A66 Northern Trans-Pennine project

Proposed changes consultation

January/February 2023

DC-16 – Removal of Roger Head Farm overbridge

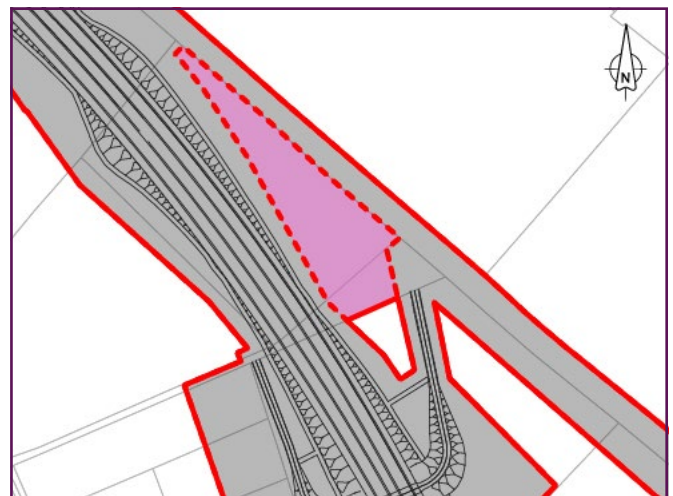
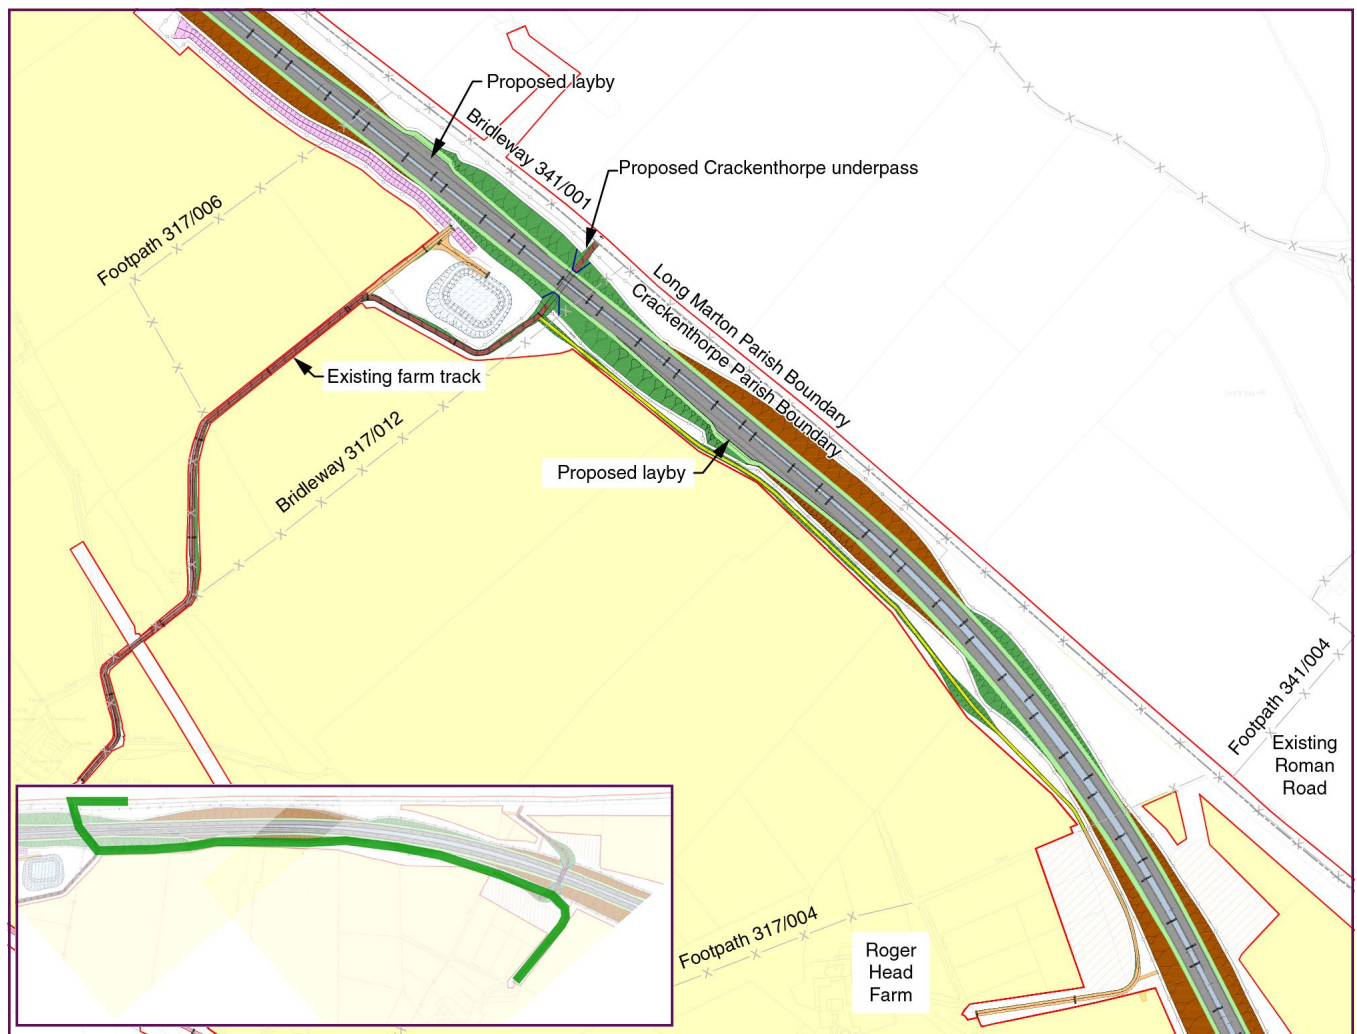
The proposed change is to no longer construct the Roger Head Farm bridge and instead divert the severed footpath, parallel to the A66 on its southern side, to an underpass 700m to the west. The underpass will provide access under the new A66 and connect to an existing bridleway on the Roman Road to the north west.

Land severed as a result of the removal of Roger Head Farm overbridge will be acquired

A small parcel of land is now isolated by this change. This will be included within the Order Limits, with the intention of using this for environmental mitigation.

DC-17 – Café Sixty Six – Revised land plan

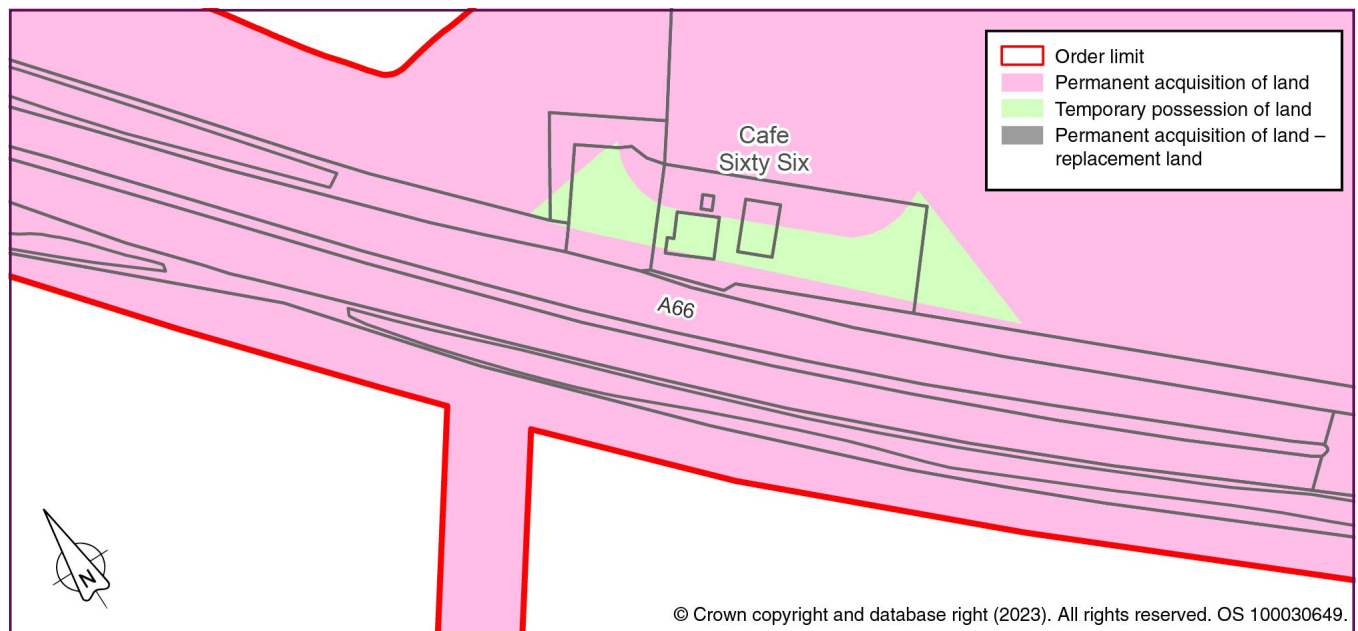
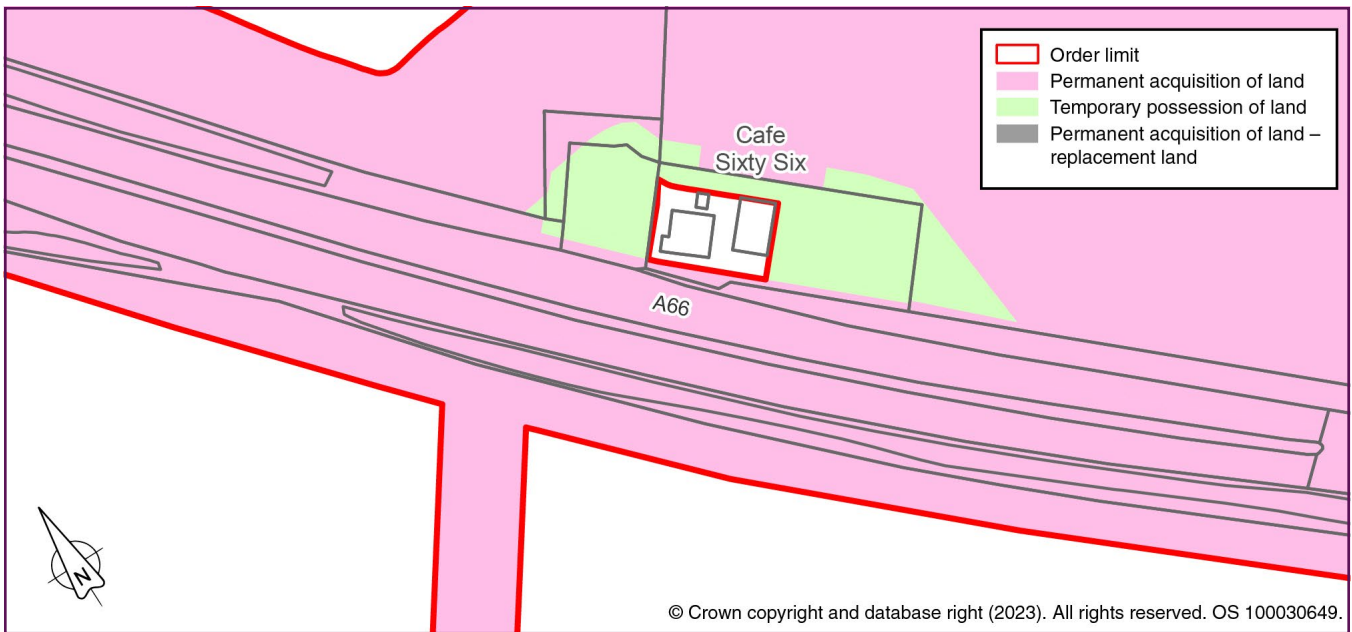
café area. Inadvertently, our plans show this loop road impacting on the café buildings.

We will correct this on our DCO plans and we are looking at opportunities in detailed design to simplify this access arrangement with input from the landowner.

This change will amend the land plans and reduce the amount of land we need to acquire from the landowner or occupy on a temporary basis.

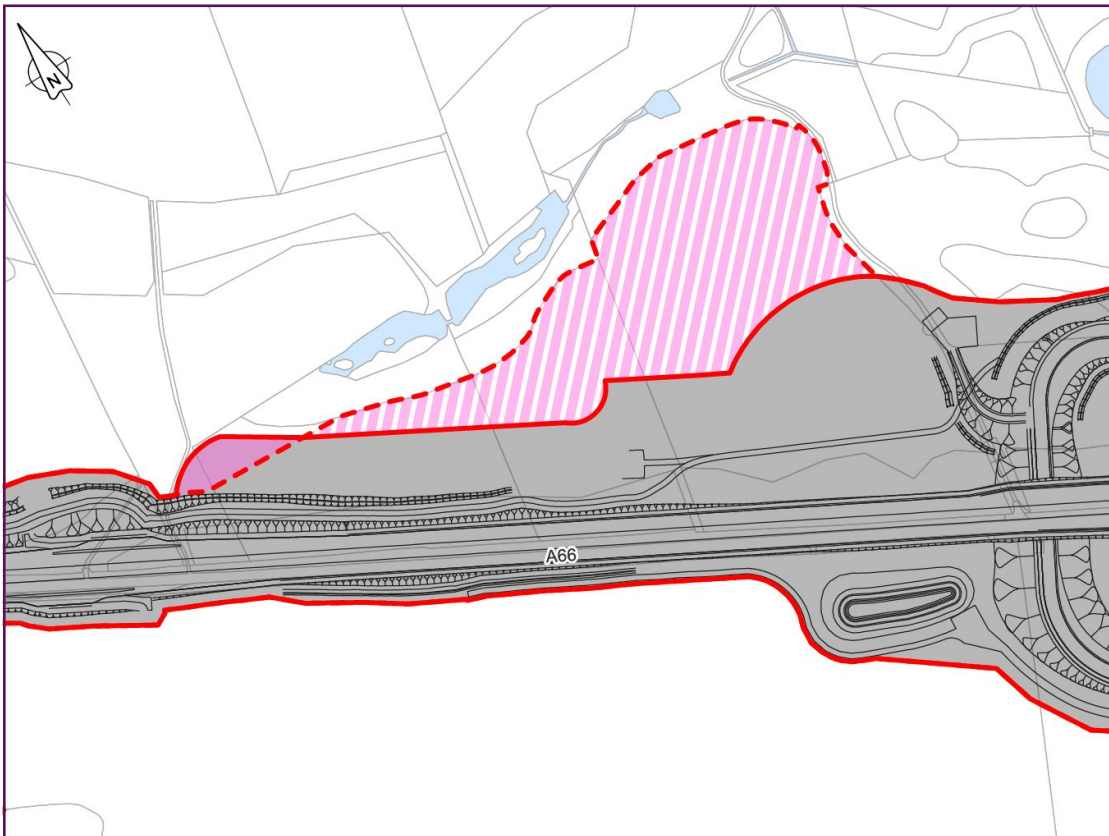
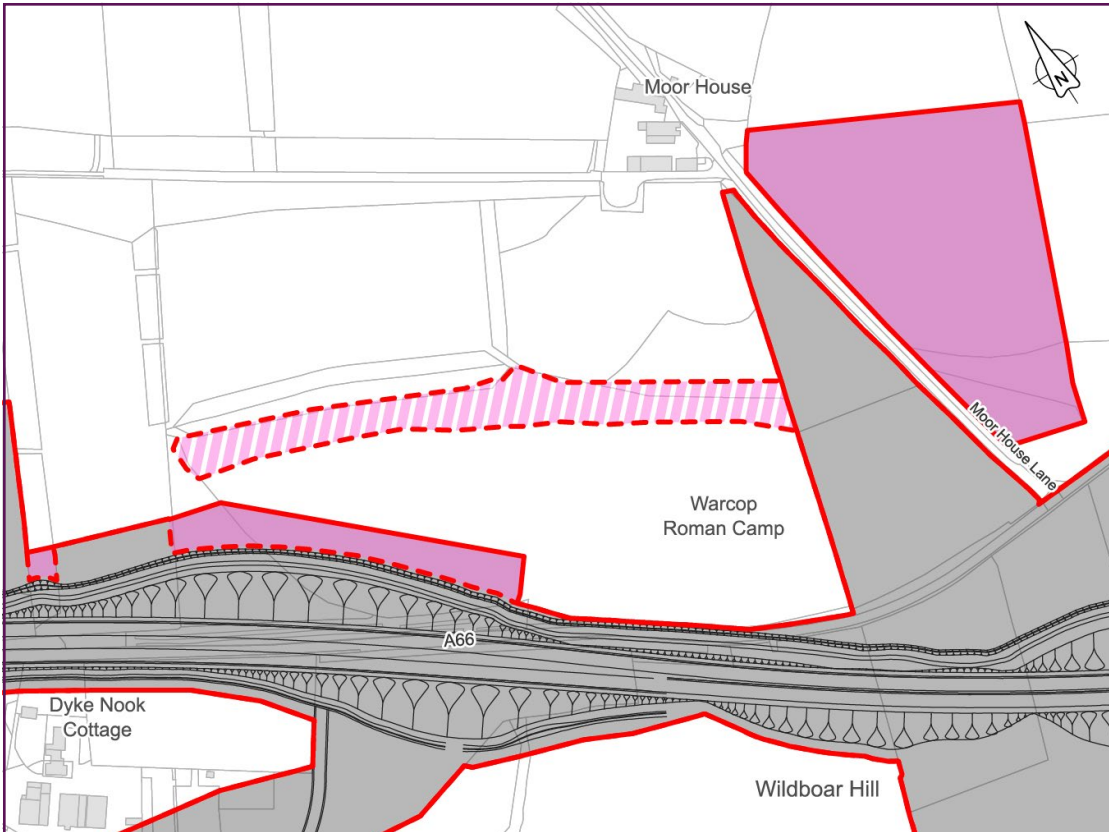
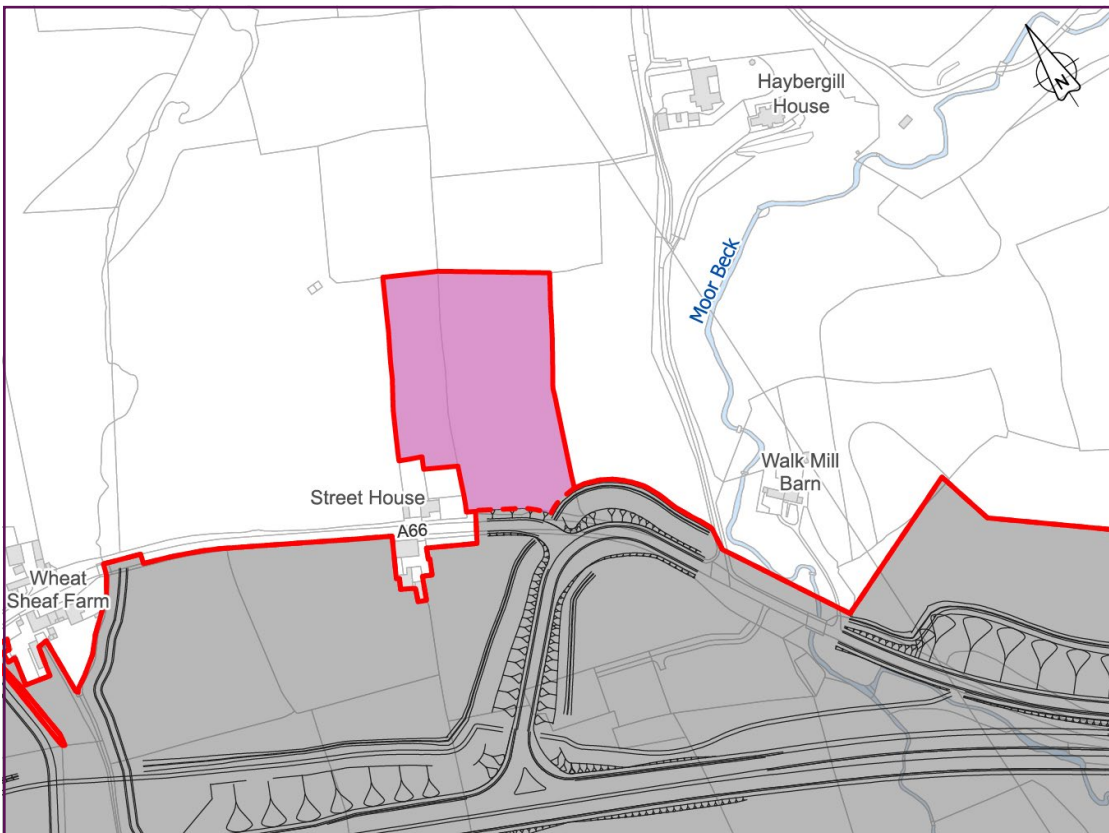
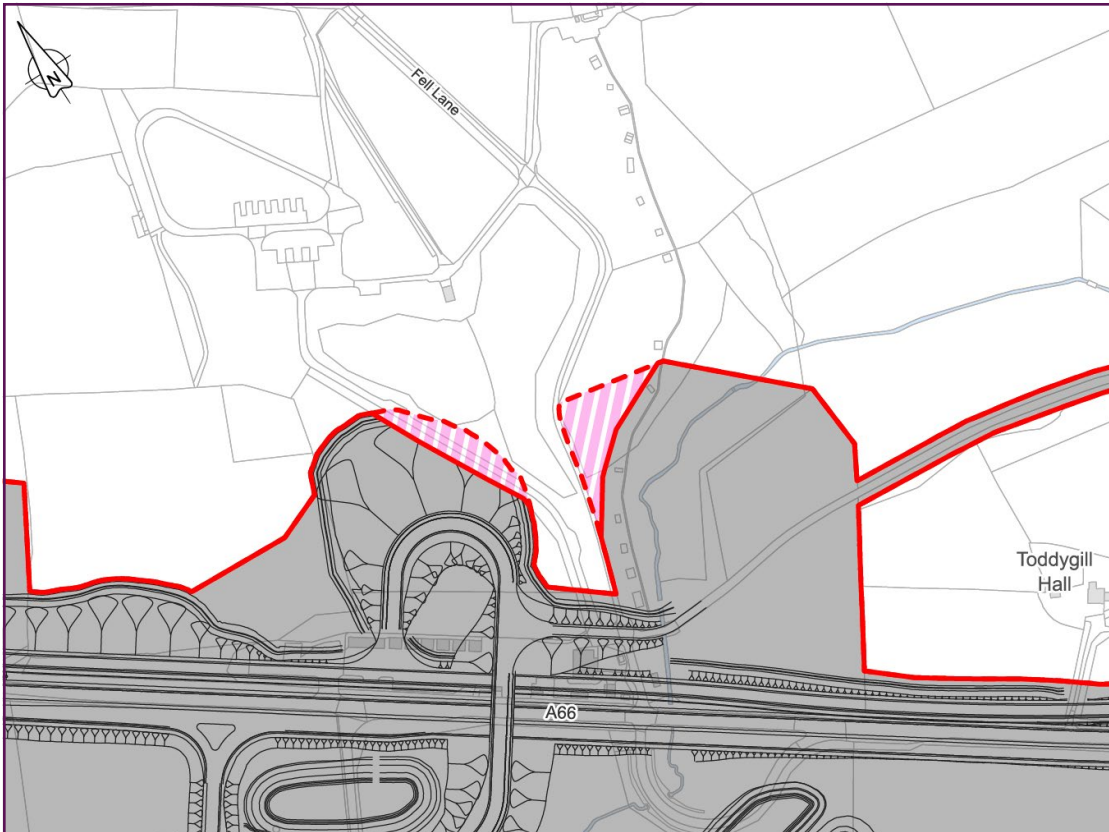
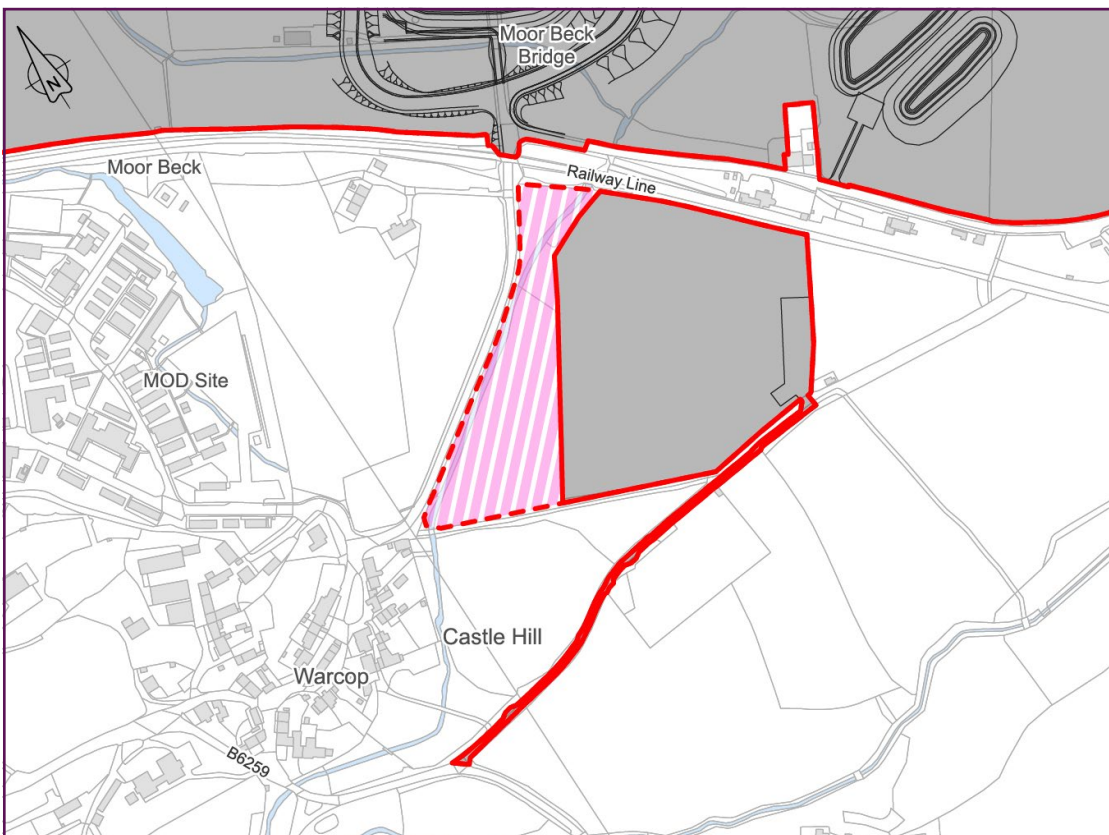
In our ongoing discussions with the MoD, they have told us that some of the land we have proposed to use for mitigation for the scheme is now required for their operational purposes, including the training of troops, which is fundamental to the functioning of the site. They have explained that areas north of the A66 are tactical land and particular locations are of strategic importance.

Amendments to the Order Limits within Ministry of Defence land. Increase in the land required to accommodate design changes to ensure the operational requirements of the site are not compromised.
